Statement of Common Ground between:

Bristol Airport Limited (BAL)

In relation to BAL's planning application (reference 18/P/5118/OUT) for development to increase the passenger capacity at Bristol Airport from 10 million passengers per annum (mppa) to 12 mppa (the Appeal Proposal), which is the subject of an appeal (reference APP/D0121/W/20/3259234) against the refusal by North Somerset Council (NSC).

Somerset County Council Drawing Number MJ004051-ED-HW-GA-0001, June 2021

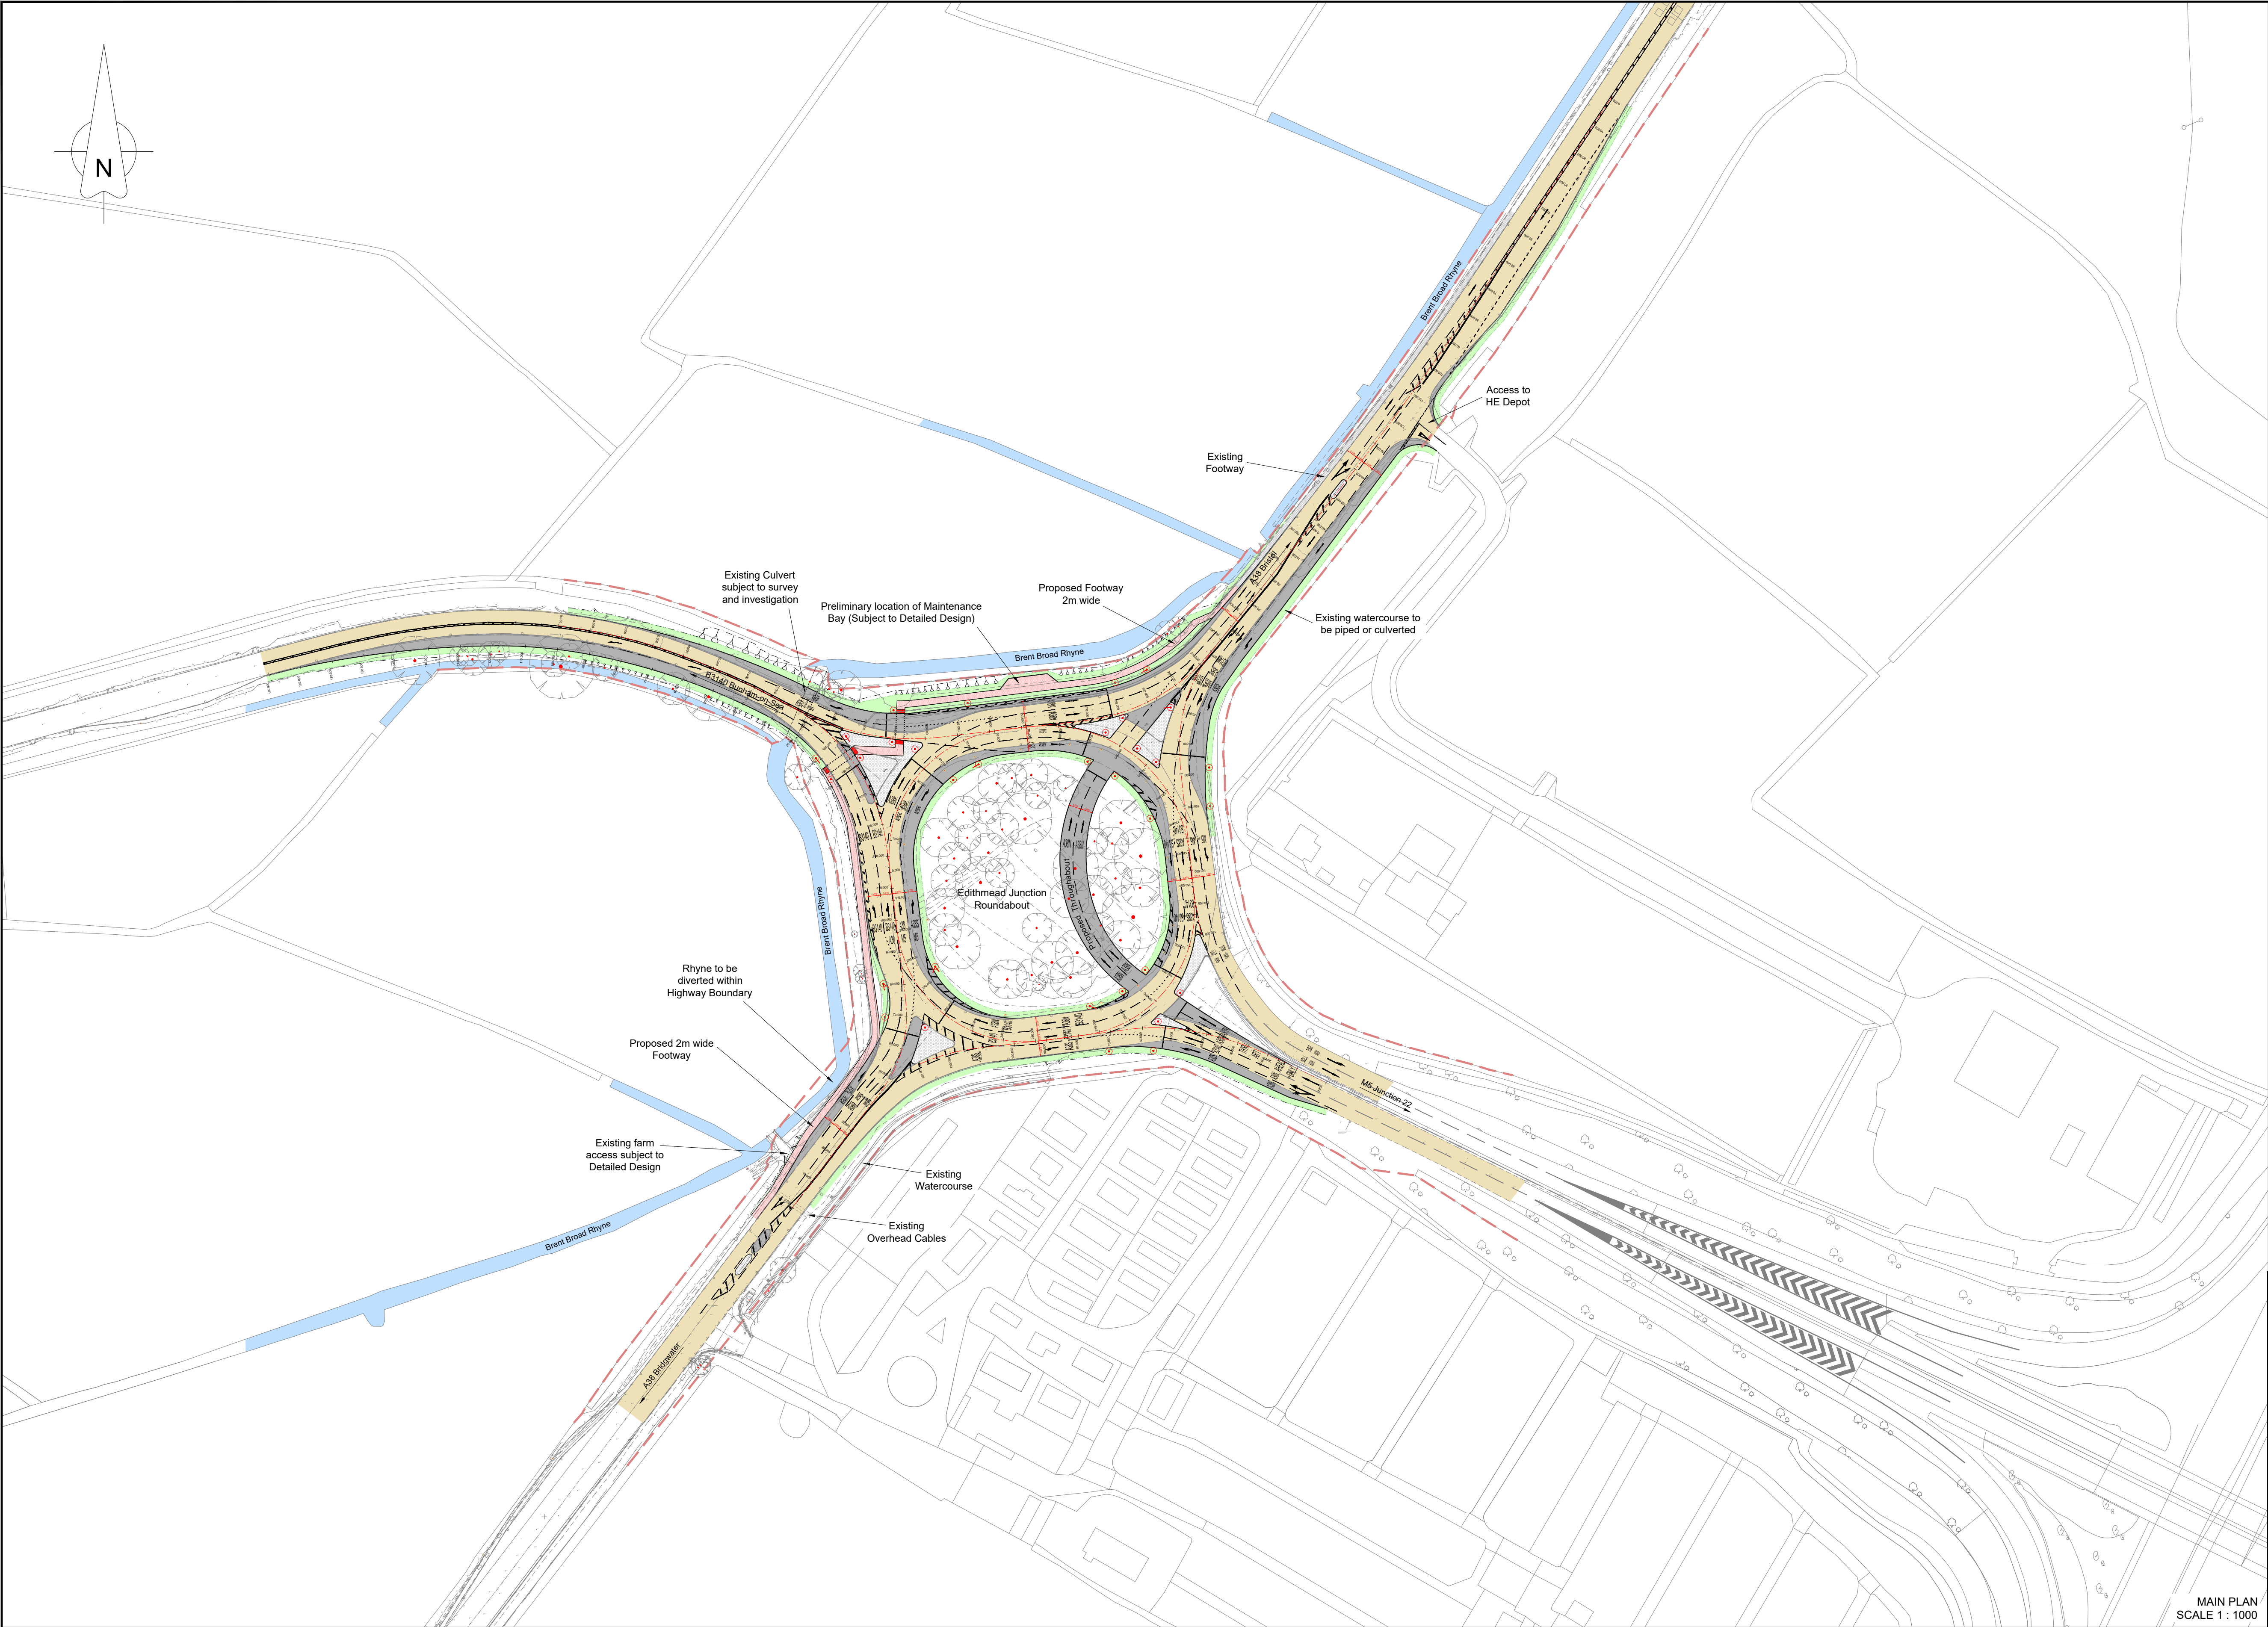
20. HE has been working with North Somerset Council and Somerset County Council as they develop their bid to the Major Road Network investment programme for the A38 Bristol Airport Access Improvements, which includes an improvement scheme at M5 junction 22 (Attached as Somerset County Council Drawing Number MJ004051-ED-HW-GA-0001, June 2021).

Within our April 2019 formal response, we noted that Highways England was in the early stages of progressing a study to refine the identified improvement scheme for M5 junction 22, and would seek to work in collaboration with the relevant local authorities and stakeholders to identify potential funding and delivery mechanisms. Since we submitted our formal response, we have been supporting North Somerset Council and Sedgemoor District Council as they develop their bid to the Major Road Network investment programme for the A38 Bristol Airport Access Improvements, which includes an improvement scheme at M5 junction 22.

a. Improvement works at M5 junction 22/A38 Edithmead roundabout, comprising the full signalisation of the A38 Edithmead roundabout, have been implemented in full and are open to traffic; or
